TECHNICAL SERVICE BULLETIN

Illuminated MIL With DTCs P0301-P0306, P0201-P0206 And/Or Various Other DTCs Stored In The PCM

25-2569

Ford 2021-2025 F-150	Engine: 3.5L PowerBoost Built on or before 14-Apr-2025
--------------------------------	---

Figure 1

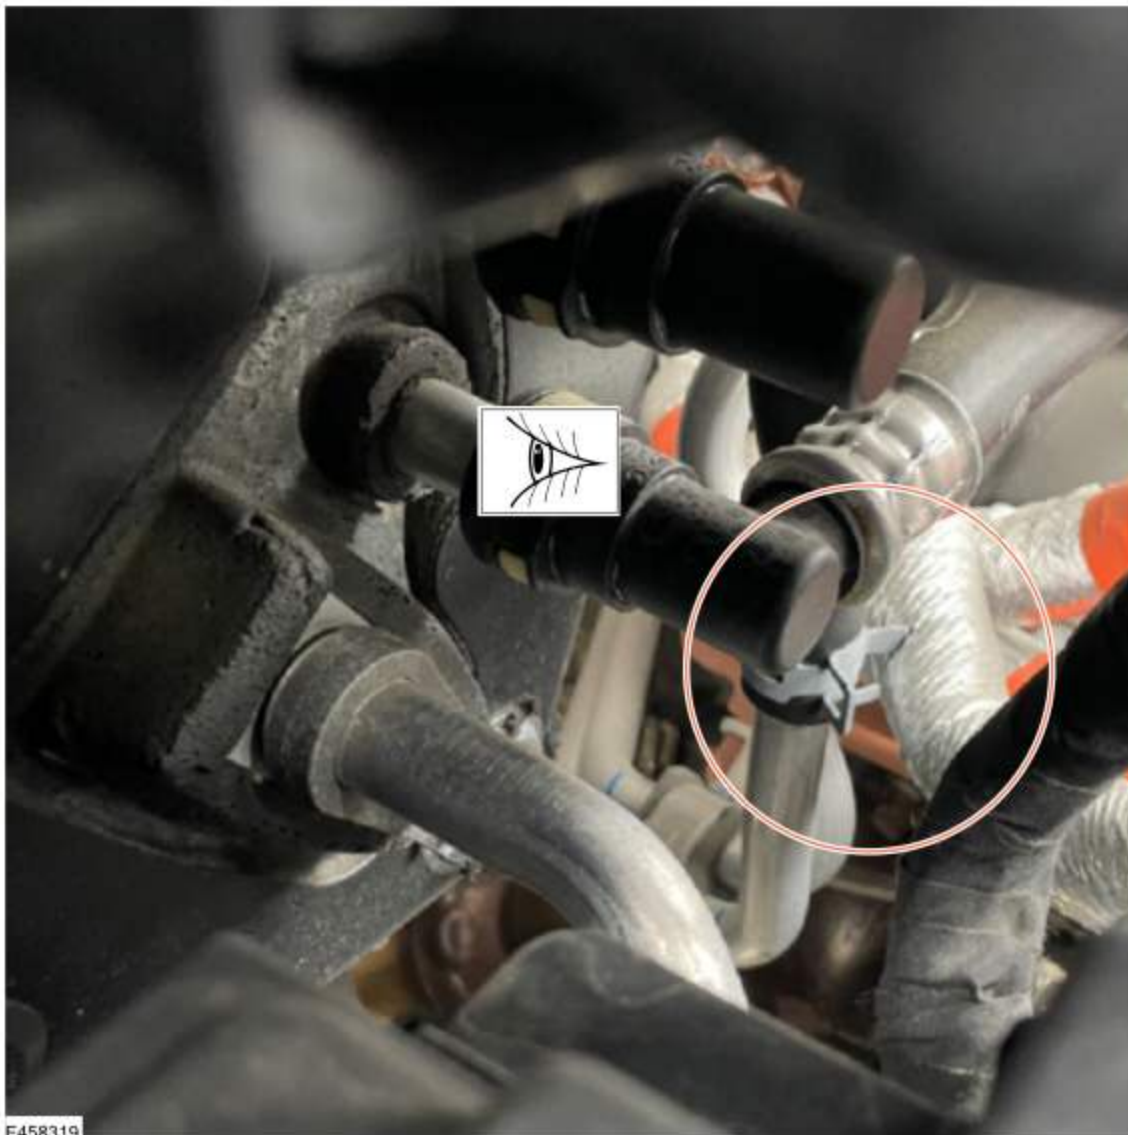
4. Locate the exhaust heat exchanger heater hose assembly spring clamp under the hood near the rear of the engine beneath the PCM. Refer to the WSM, Section 303-03C > Description and Operation > Component Location and Figure 1. Observe the orientation of the spring clamp. Are the heater hose clamp tangs pointed toward and/or contacting the 12A581B engine harness? (Figure 1)

- (1). Yes - rotate the hose clamp 180 degrees so that the tangs are orientated away from the harness. (Figure 2)
Proceed to Step 5.

Figure 3

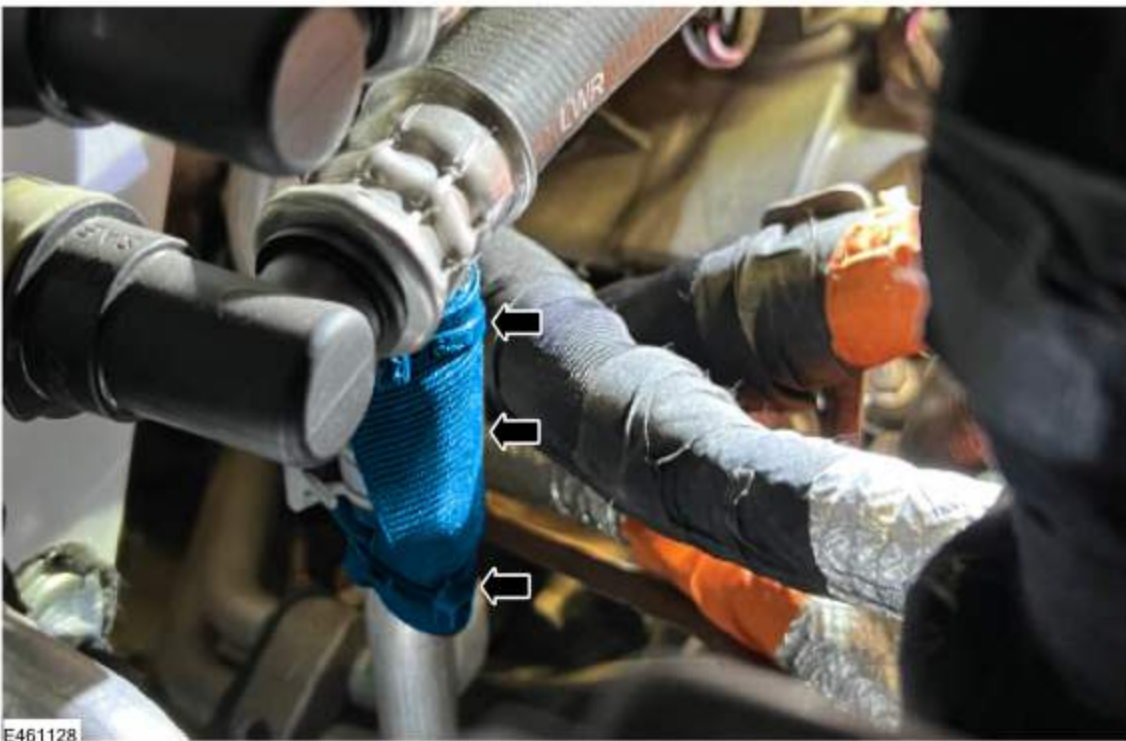
5. Using a shield protector, wrap the hose with the shielding centered over the hose clamp or hose crimp end with the opening of the shield protector facing the clamp tangs. Secure in place using a cable tie at each end. (Figure 3)
